Product Change Notification

Issue Date: March 22, 2017

Product Name: EBC-3220 chassis

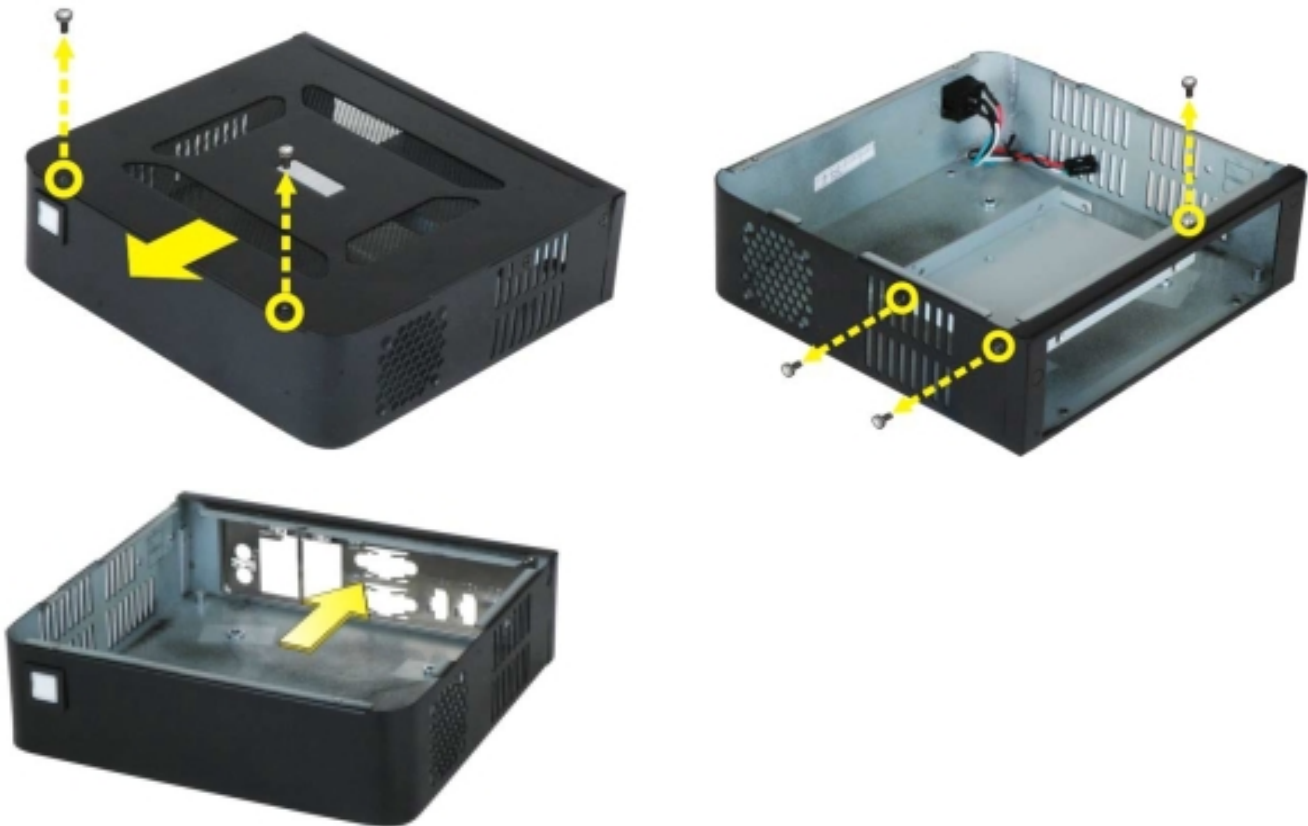
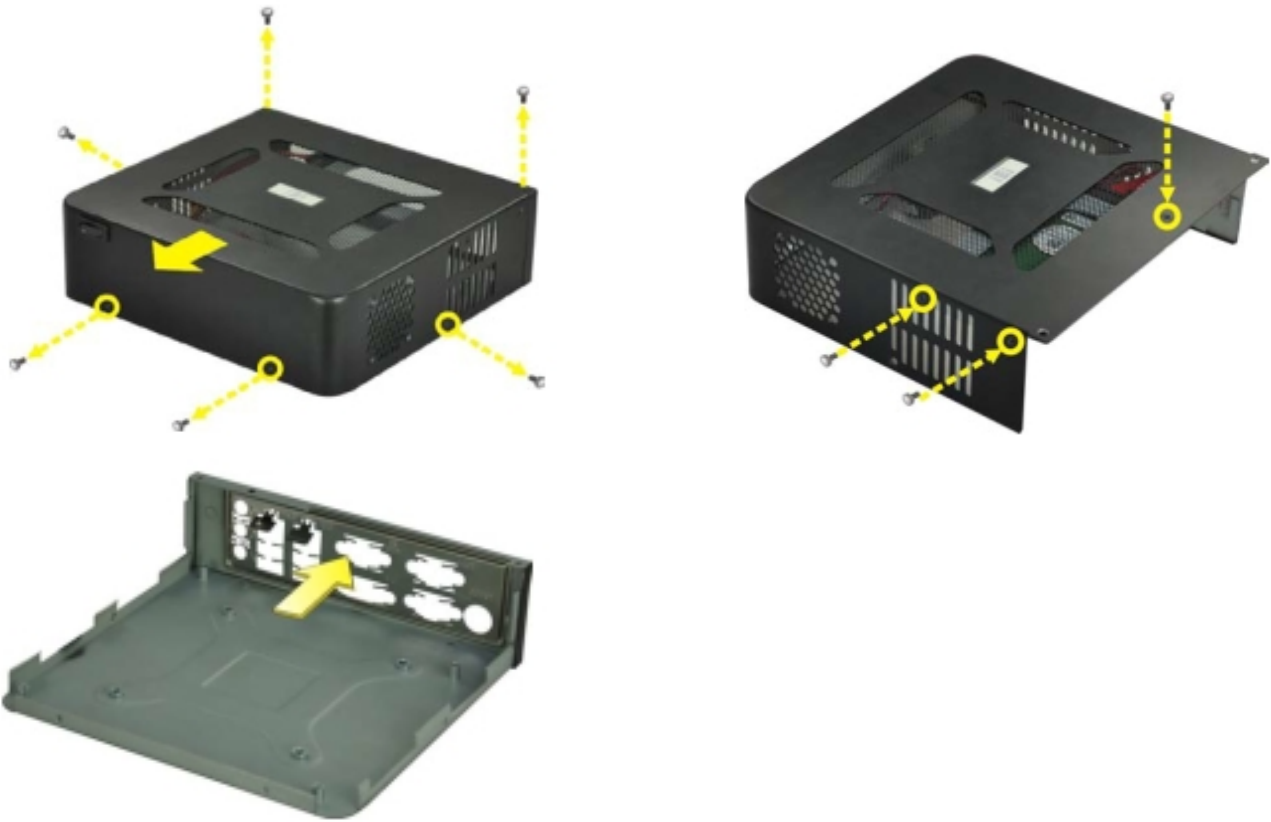
Change the chassis assembly method for product compatible enhancement

Change product from EBC-3220-R10 to EBC-3220-R11.

1. Chassis assembly method
2. Power switch module to reduce the mechanical interference with motherboard I/O
3. The lock method of HDD bay

Detail please refer to QIG V1.00 (PN:51000-023903-RS)

Detail please refer to QIG V1.10 (PN: 51000-024253-RS)
